UDRP Chair Dr Philip Pollard and UDRP Heritage expert Mr Colin Brady - brief observations in respect to the additional information arising from:

- The Visual Impact Assessment Review, prepared by Envisage Consulting Pty Ltd dated 4 October 2024 for the *Review of Determination* Concept Modification Proposal *Stage 3 and 4 of East End Development* at 121 Hunter St Newcastle; and
- The Response to Request for Further Information prepared by Urbis, dated 26 September 2024; and
- Addendum To Heritage Impact Statement (HIS) Dated 10 September 2024, Prepared by City Plan (Heritage) In Response To Request For Additional Information - Heritage Matters Newcastle East End Stages 3 & 4 - RE2024/00002

The following opinions were prepared by UDRP Chair, Dr Philip Pollard, and by Mr Colin Brady, and are offered in response to the further information provided to CN since the UDRP's most recent consideration of the proposal on 26 June 2024, in respect to the East End Concept Plan Stages 3 & 4 Modification. The two relevant documents are the Envisage Visual Impact Assessment Review prepared by Stacey Brodbeck (VIA review) dated 4 October 2024, and the Response to Request for Further Information p

Figure 13: View to Cathedral & the Hill from the pathway approx. 60m west of Stockton Ferry Wharf – At approximately the southern end of Mitchell Street. There will be no obstruction by any proposed building, of any part of the Cathedral from this location or anywhere west of it.

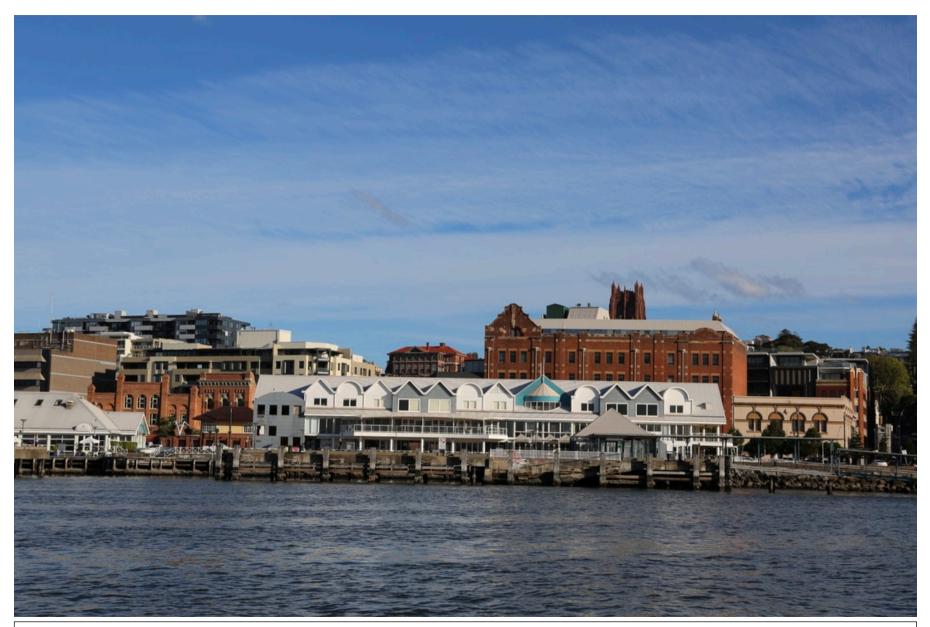
The location on the Stockton foreshore that is directly facing the alignment of the northern transept of the Cathedral with a (proposed) view directly along Market Street, is only a short distance – approximately 60m – east of the Ferry terminal. View Points A and B are not "side on" to the Cathedral as suggested, but are situated some 375m (View Point B) and 450m (View Point A) to the east of the Ferry terminal, and are obtusely angled to the street-grid on which the Site and the Cathedral are aligned. These two View Points are located just beyond the bend where the river turns towards the north-east and out to the open sea.

View Points A and B are obtained from a shared pathway which runs in line with the curved shoreline. They are located towards the eastern extremity of the foreshore arc, and are not associated with any activity nodes – such as a shelter or seating, which might encourage walkers to pause at these particular points, and thereby take in the static view. Such shelters are provided closer to the Ferry Terminal, and the terminal is a point at which travellers pause to await the ferry. A further major gathering point is provided at the turning circle at the southern end of Mitchell Street, which has a café, skate-bowl, amenities and childrens' playground to its western side. At this point, and everywhere to the west of Mitchell Street, the proposal does not obscure any part of the Cathedral. In my opinion, the selection of View Points A and B places an inappropriately significant weight upon these locations, and ignores other areas, such as the multiple attractors around the southern end of Mitchell Street Stockton, which encourage people to linger and to potentially take in the direct views to the Market Street corridor and the Hill. (See photo at Figure 13 on P.27)
